From: Amber Willard
Sent: 17 July 2019 14:01
To: Planning.Responses
Subject: FW: y/8/19/hh
Attachments: Hazel Cottage - REV A - Drawing Pack - LDB - 17.07.2019.pdf

Hazel Cottage Y/8/19/HH

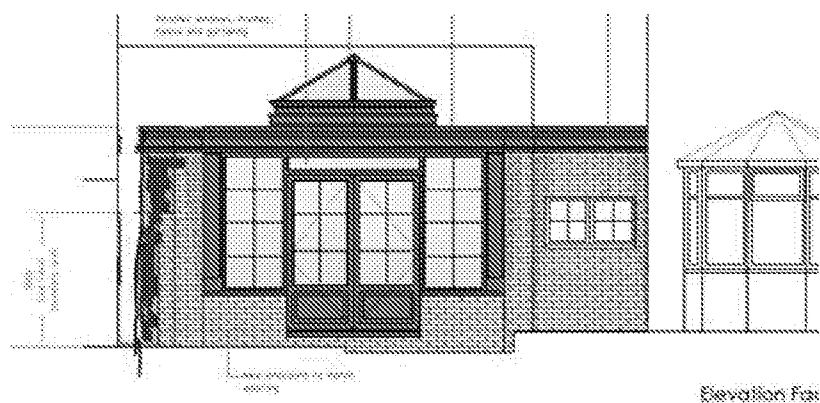
We are still concerned about the low level wall that is to be built. We feel to ensure there is no damage to the boundary listed wall, would you propose to not construct this and leave a small gap between the extension and the wall.

I have tried to colour it in on the plan below to show what I mean.

Yes that would be acceptable.

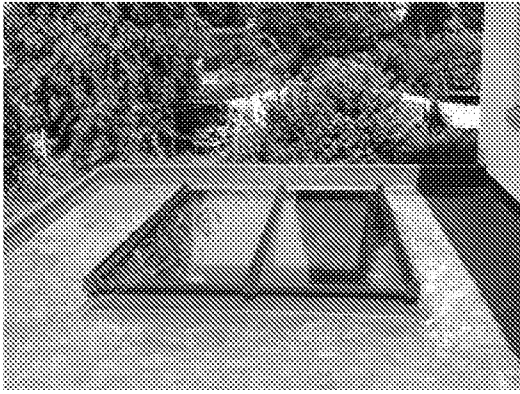
- Do you know the height of the boundary wall to the neighbouring listed building. Will the extension be taller than this and how much by as it is not clear on the plans.
- The low level boundary wall, is this proposed to be built alongside the boundary (listed wall) to separate it as such. If so it seems to create a void and then joins the wall, can you confirm if this is the case. (as shown below).

- Do you know the height of the boundary wall to the neighbouring listed building. Will the extension be taller than this and how much by as it is not clear on the plans. **THE BOUNDARY WALL IS 2.250M HIGH. THE PROPOSED EXTENSION IS 2.975M HIGH.**
- The low level boundary wall, is this proposed to be built alongside the boundary (listed wall) to separate it as such. If so it seems to create a void and then joins the wall, can you confirm if this is the case. (as shown below). **YES, THIS IS TO KEEP THE MAIN STRUCTURE AND ANY ROOF OVERHANG AWAY FROM THE BOUNDARY WALL**

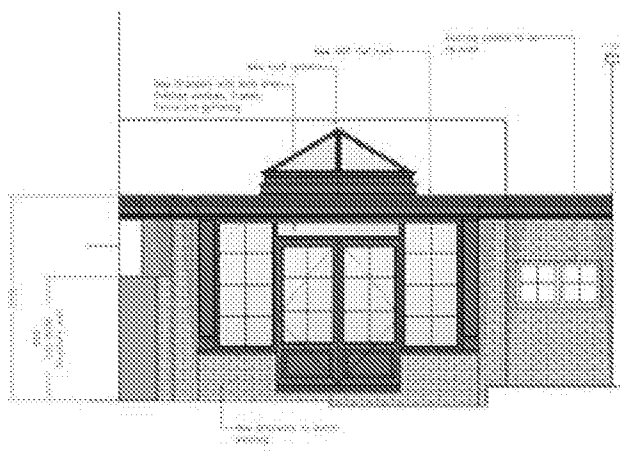
- The roof light is a dominant feature at around 1m in height and visible from the neighbouring property. Would you be willing to lower this feature?

- The roof light is a dominant feature at around 1m in height and visible from the neighbouring property. Would you be willing to lower this feature? **YES, THIS WOULD BE ACCEPTABLE. WE COULD PROPOSE A FLAT ROOF ROOFLIGHT:**
